Office Action Summary	Application No. 10/780,169	Applicant(s) WALLER ET AL.
	Examiner JASON S. UHLENHAKE	Art Unit 2853

DETAILED ACTION

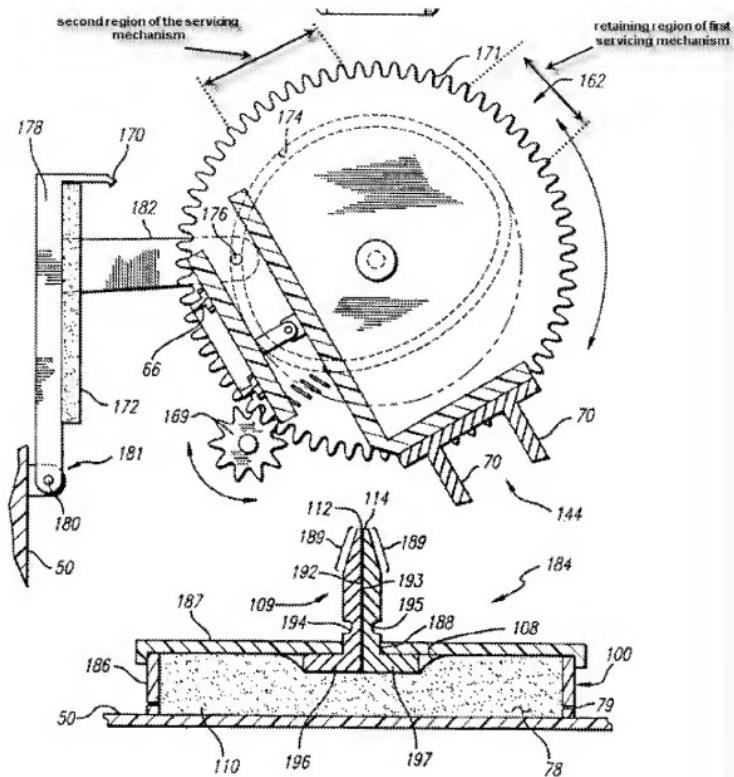
- ***regarding claim 31***, a driveshaft (82); a sled (180) including a rack (198) adapted to selectively engage the driveshaft and a retaining wall (housing structure 52) positioned to retain the driveshaft on the rack in a zone (Column 7, Lines 28-30, Lines 45-55; Column 8, Lines 11-27)

- ***regarding claim 32***, the driveshaft is shiftable between a disengaged position and an engaged position where the driveshaft engages a powered gear and rack (Column 7, Lines 28 – 30, Lines 45 – 55; Column 8, Lines 11 – 27)

- ***regarding claim 33***, the powered gear is operatively connected to a power shaft (124) that, when the driveshaft is in the engaged position, the powered gear transmits power to the driveshaft (Column 5, Lines 17-35)

- ***regarding claim 34***, the powered gear is an idler gear and where the power shaft transmits power to the driveshaft through the idler gear (Column 7, Lines 28 – 30, Lines 45 – 55; Column 8, Lines 11 – 27)

- ***regarding claim 35***, a shift arm (146) that moves between an engaged position and a disengaged position, wherein movement of the shift arm (146) from the disengaged position to the engaged position moves the driveshaft into engagement with the idler gear and the rack (Column 7, Lines 28 – 30, Lines 45 – 55; Column 8, Lines 11 – 27)

- ***regarding claim 38***, a motor (102) that drives the power shaft (Figure 4)
- ***regarding claim 39***, a sled further includes a cap (182, 184), a wiper (186, 188) and a spittoon (68a, 68b)

Figures 4 and 5: Retaining walls

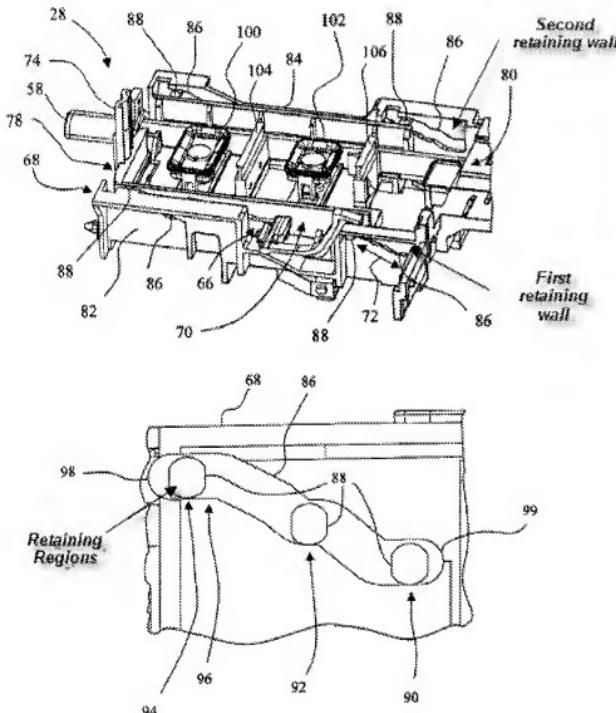
- ***regarding claim 16***, a biasing member that biases the drive structure to move from the first engaged position to the disengaged position, the first retaining wall including a retaining region that retains the drive structure in the first engaged position and against biased movement to the disengaged position when the drive structure is positioned within the retaining region (Figures 4 – 5; Paragraphs 0008; 0044 – 0045; 0050), for the purpose of guiding and securing a maintenance sled.

- ***regarding claim 17***, a biasing member that biases the drive structure to move from the first engaged position to the second engaged position, the second retaining wall including a retaining region that retains the drive structure in the first engaged position when the drive structure is positioned within the retaining region (Figures 4 – 5; Paragraphs 0008; 0044 – 0045; 0050), for the purpose of guiding and securing a maintenance sled.

- wherein the biasing member biases the shift arm to pivot from the actuated position to the non-actuated positions; a printhead carriage operable to pivot the shift arm from the non-actuated position to the actuated position by overcoming a biasing force of the biasing member (Figures 4 – 5; Paragraphs 0008; 0036; 0044 – 0045; 0050), for the purpose of guiding and securing a maintenance sled.

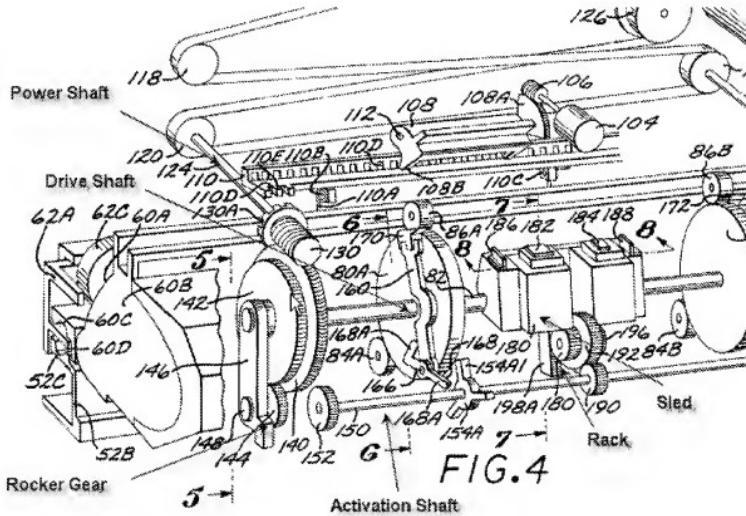
Regarding claim 13, applicant argues that Hirano does not disclose a servicing station drive structure. Hirano discloses cams 34a and 37a which moves/drives the caps (34, 37) to pivot toward the printing head (Column 5, Lines 53-59). The service station drive structure is moveable between a disengaged position, a first engaged position (when the cap 37 is moved by the cam and is engaged with black head 11), and a second engaged position (when a cap 34 is moved by the cam and is engaged with color heads 20-22), the drive structure in the first engaged position engaging the

first engagement structure and the drive structure in the second engaged position engaging the second engagement structure (Figures 1, 3)

Further regarding claim 13, applicant argues that Hirano discloses multiple biasing members and separate springs do not constitute a singular member. Claim 13 discloses a printer comprising a biasing member that biases a service station drive structure. Comprising is open-ended which does not exclude multiple biasing members and the claim does not define the biasing member to include only one spring or biasing member.
